## Detailed Site Plan Alternative Compliance Dobson Ridge

**DSP-20007**  
**AC-21009**

SUBJECT:      Detailed Site Plan DSP-20007  
                 Type 2 Tree Conservation Plan TCP2-013-2021  
                 Alternative Compliance AC-21009  
                 Dobson Ridge

**Figure 4: Sign Elevations**

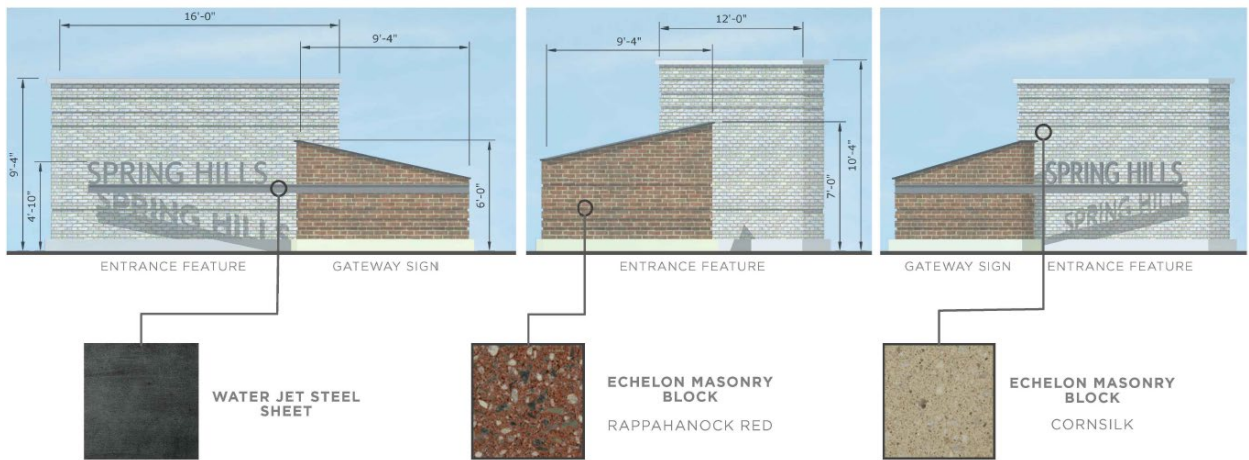
It is unclear if the signs are illuminated, and staff recommends this information be shown, as conditioned herein. In addition, it is also recommended that if the sign is illuminated the lighting not cast glare onto the roadway or residential lots.

- r. Indicate if the gateway sign is illuminated and provide the applicable details.
- s. Provide a brick tracking chart to ensure a minimum of 60 percent of all townhouse units have a full front facade (excluding gables, bay windows, trim, and doors) of brick, stone, or stucco.
